Sandata Mobile Connect (SMC)

Global Release VC 2025.12.01

Mobile Version 3.4.4

HHAeXchange Accessibility Testing Update

VC-1213: ADA Compliance – 1.3.1 Info and Relationship

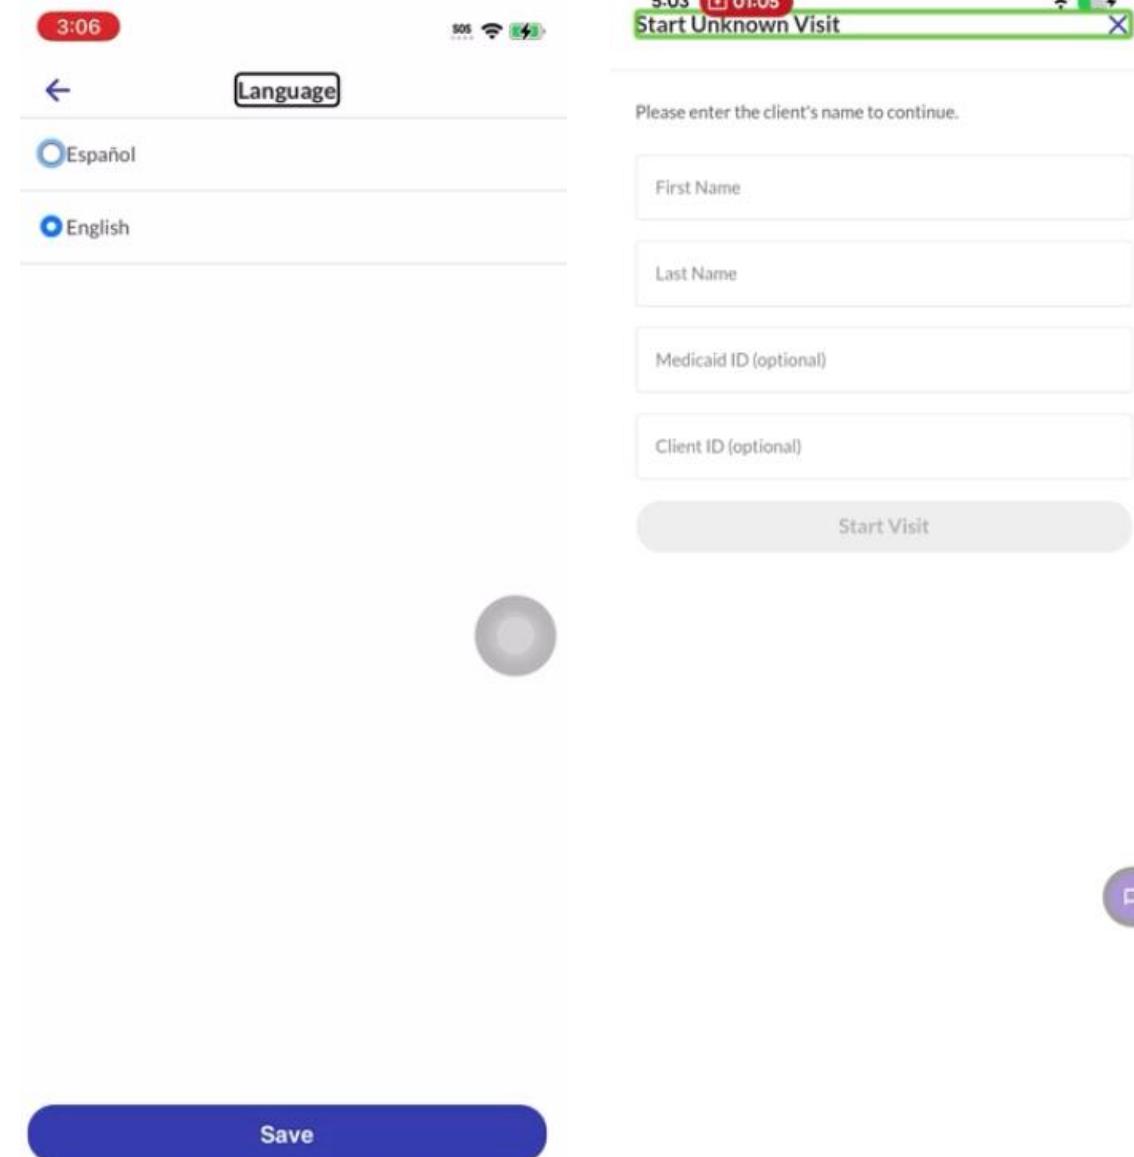
- Both iOS and Android
- Issue(s): Some of the headings are missing proper role.
- Fix: All the visual section headers need to be marked up and recognized as a **heading** by the screen reader

VC-2148: ADA Compliance – 2.1.1 Keyboard

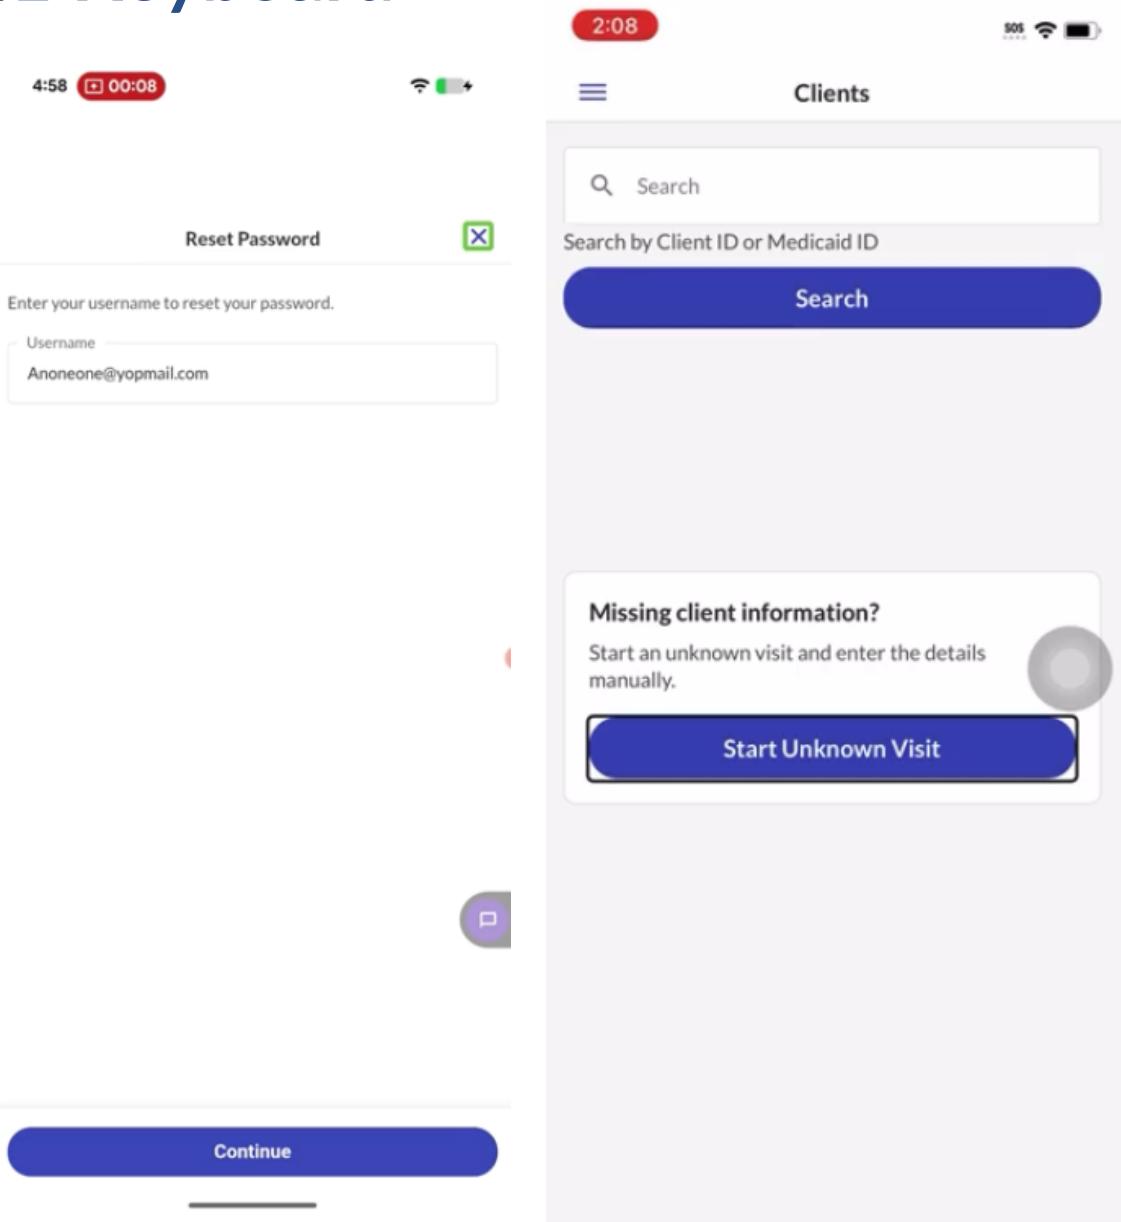
- Both iOS and Android
- Issue(s): Not all functionality can be accessed and performed using a keyboard

Reset Password: the close button does not receive focus while screen reader is on.

Menu: When an edit box is triggered, the keyboard does not have a next button to move to the next edit box.

- Fix: All the visual section headers should have programmatic mark up to be recognized as heading by the screen reader. All the screen titles should have a heading mark up.

VC-2149: ADA Compliance – Name, Role, Value

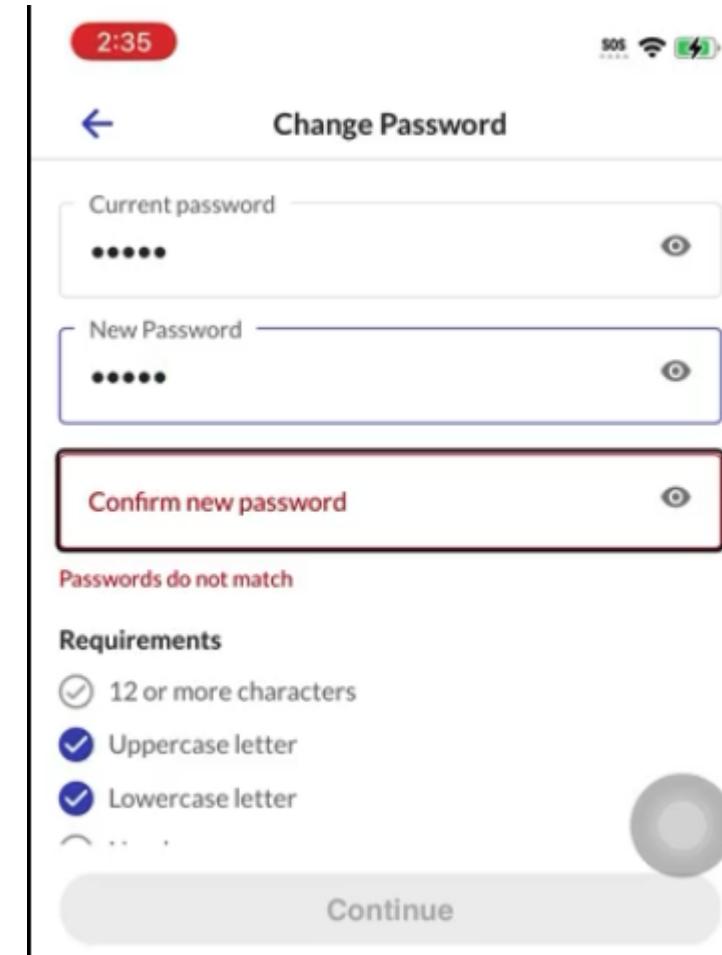
- Both iOS and Android
- Issue(s)

Change Password - Screen reader does not read the error messages as it appears on the screen.

Menu/Help Button - The menu and the help button are missing role of button.

Reset Password – The close button does not have a role of button.

- Fix: All the visual section headers need to have programmatic mark up as heading by the screen reader.
